Subject: Gibbs & Hill Responses to Pipe Stress Questions  
Comanche Peak Steam Electric Station  
Independent Assessment Program - Phase 3  
Texas Utilities Generating Company  
Job. No. 84042

TEXAS UTILITIES GENERATING COMPANY  
COMANCHE PEAK STEAM ELECTRIC STATION  
G&H PROJECT NO. 2323  
FOLLOWUP INFORMATION FROM G&H  
REF: CYGNA COMMUNICATIONS OF 5/24/84

8.0  
7.5  
7.0  
6.5  
6.0  
5.5  
5.0  
4.5  
4.0  
3.5  
3.0  
2.5  
2.0  
1.5  
1.0  
0.5  
0.0  
-0.5  
-1.0  
-1.5  
-2.0  
-2.5  
-3.0  
-3.5  
-4.0

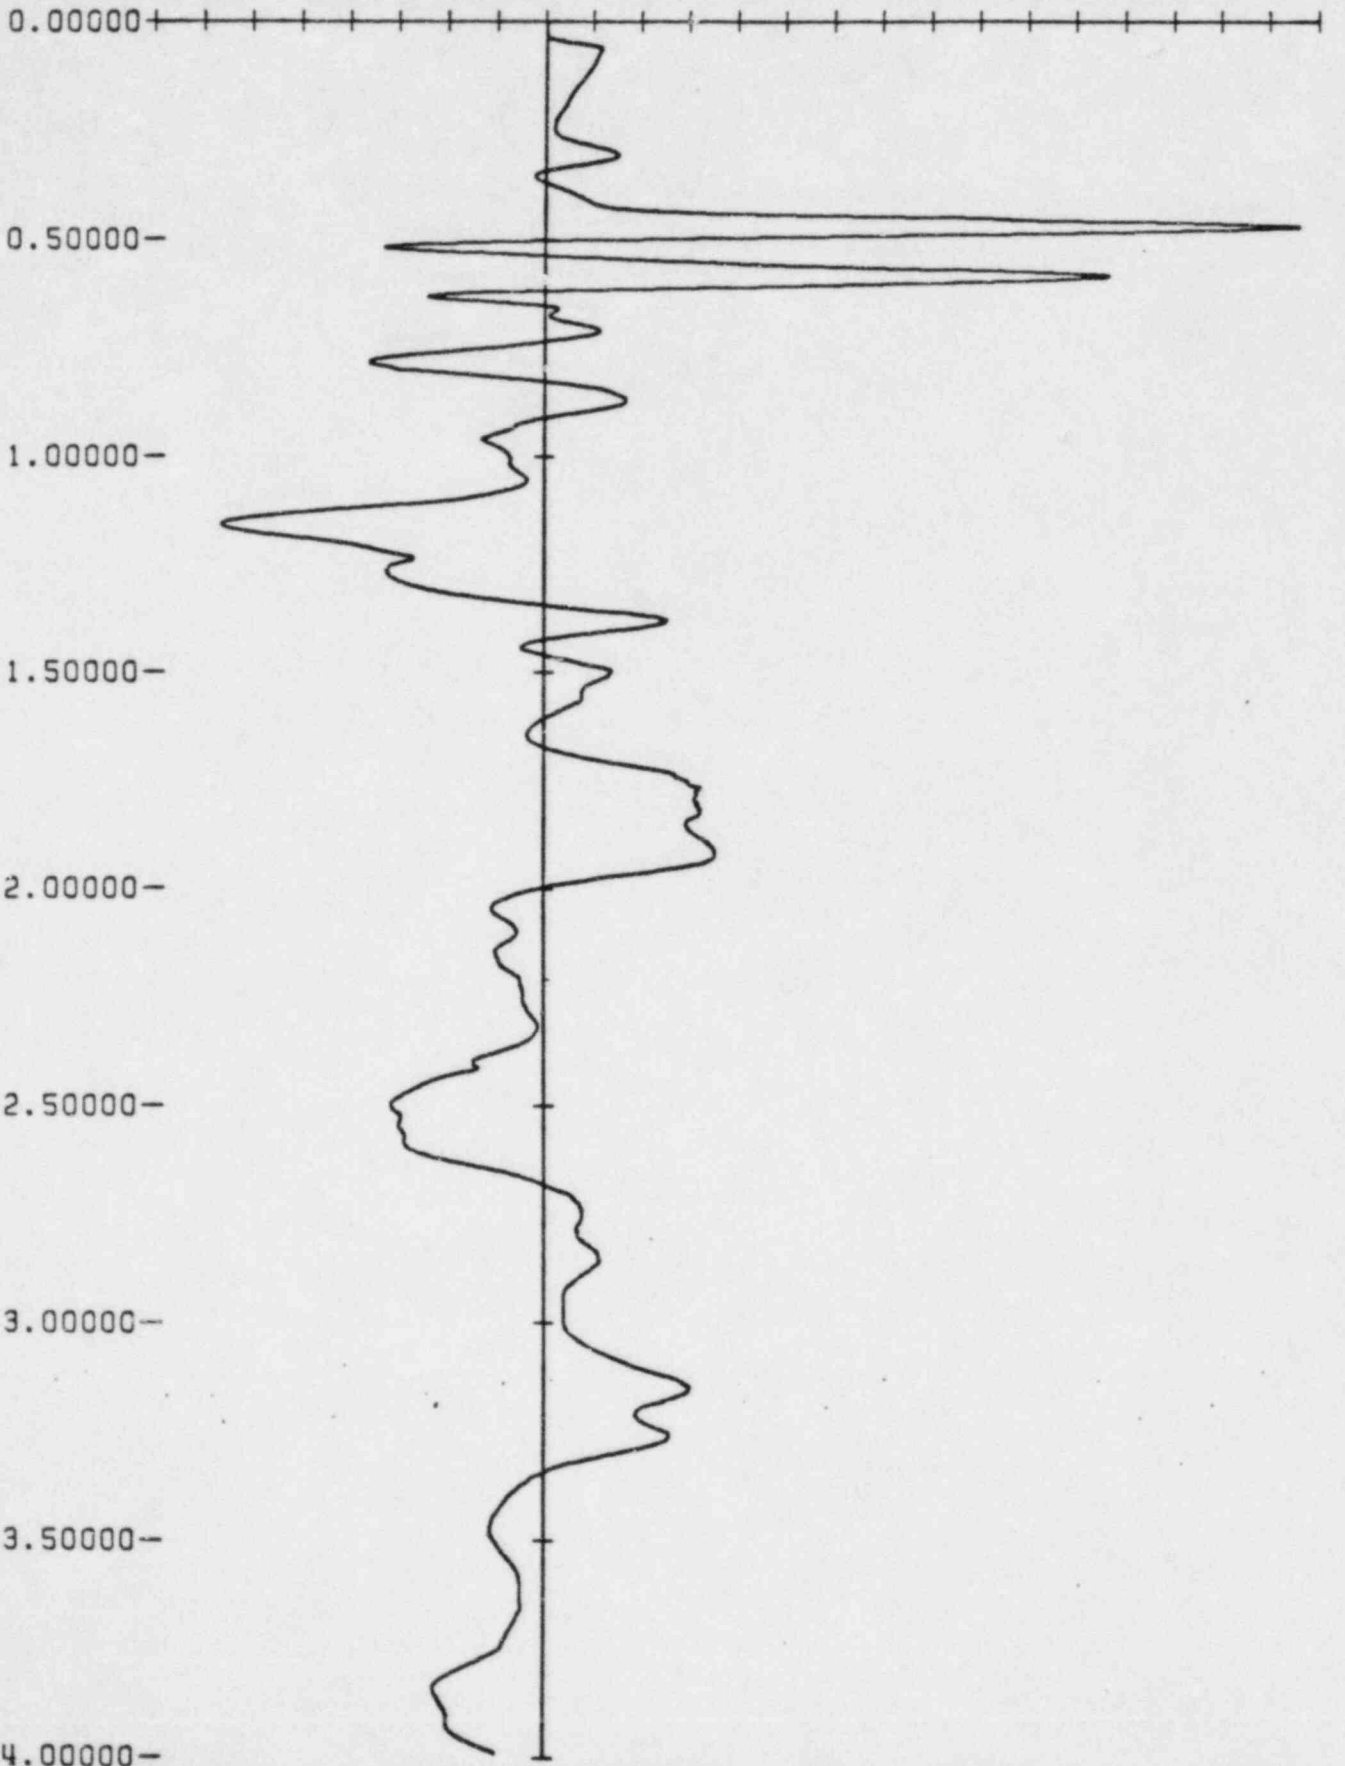
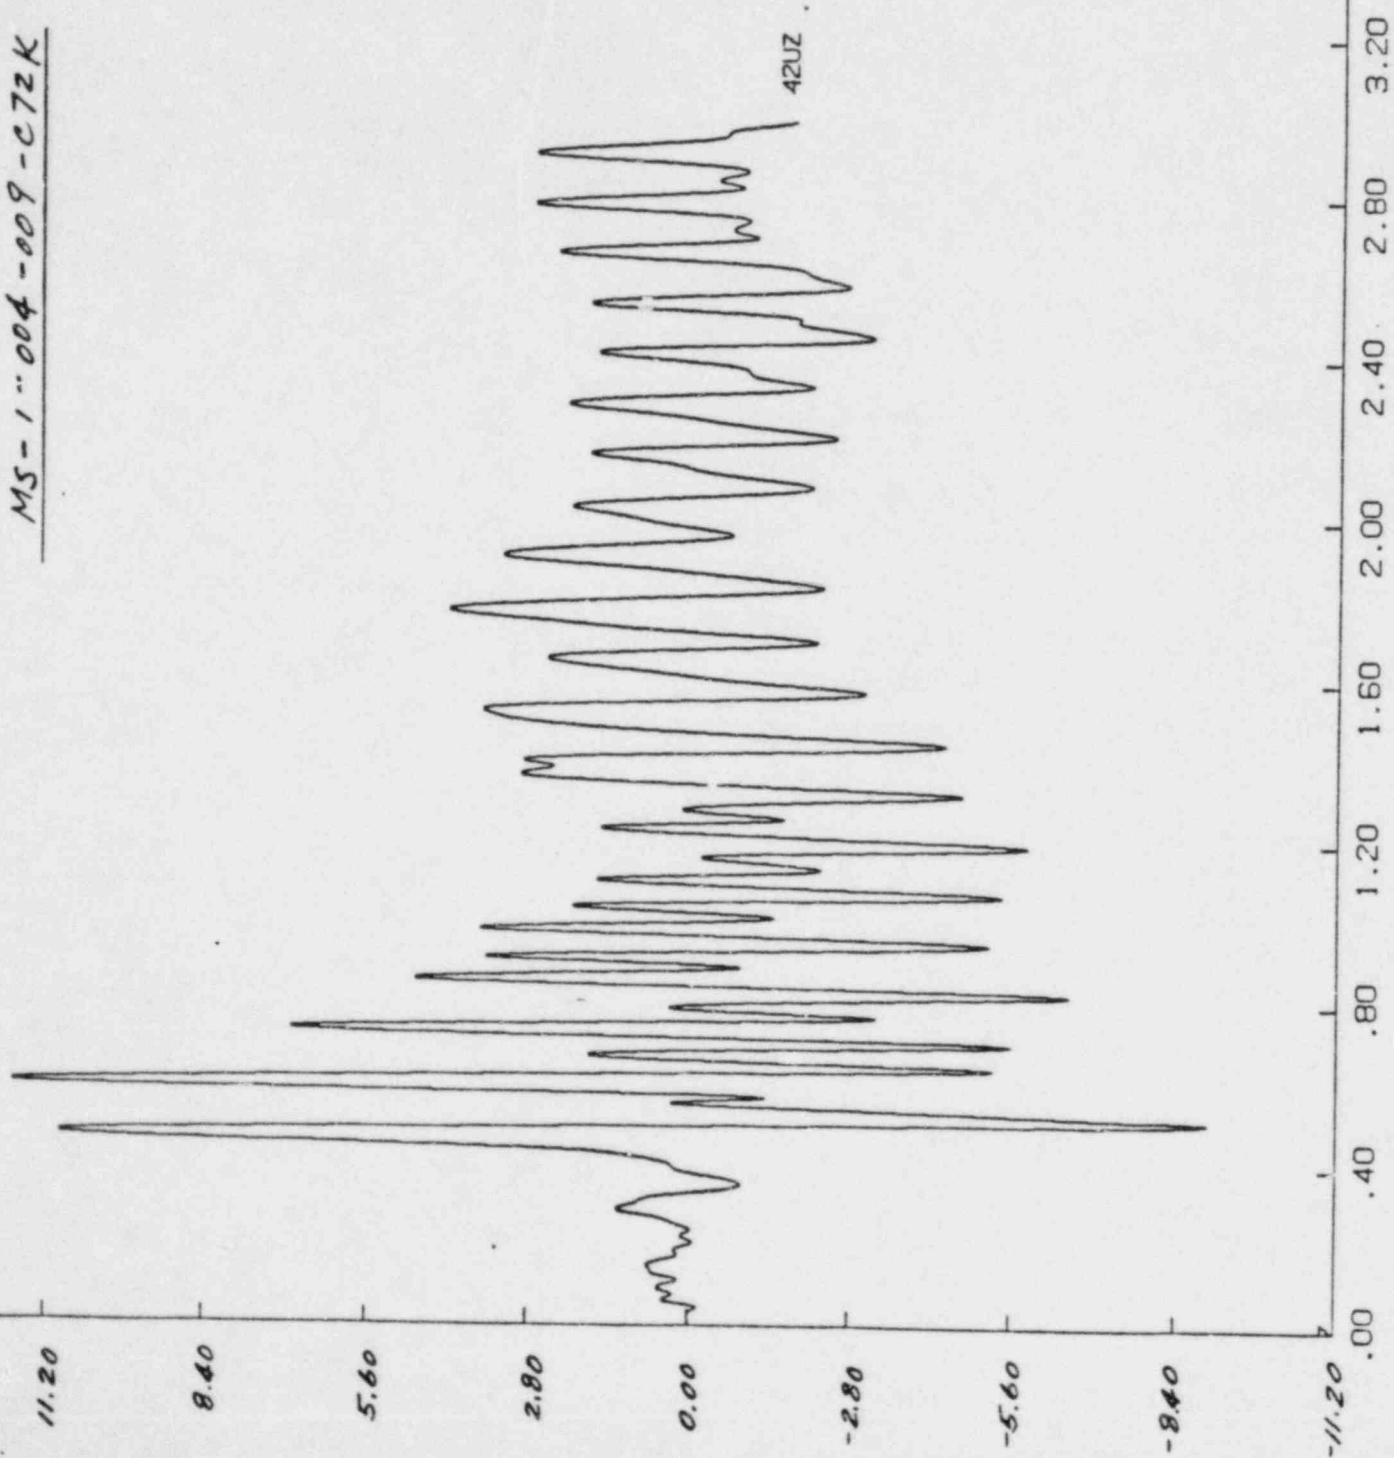
Item 34 - Plots of axial forces on supports.

Attached are plots of steamhammer forces on axial restraints for main steam loops 1 thru 4. Also included are the plots of the net unbalanced forces for the associated legs.
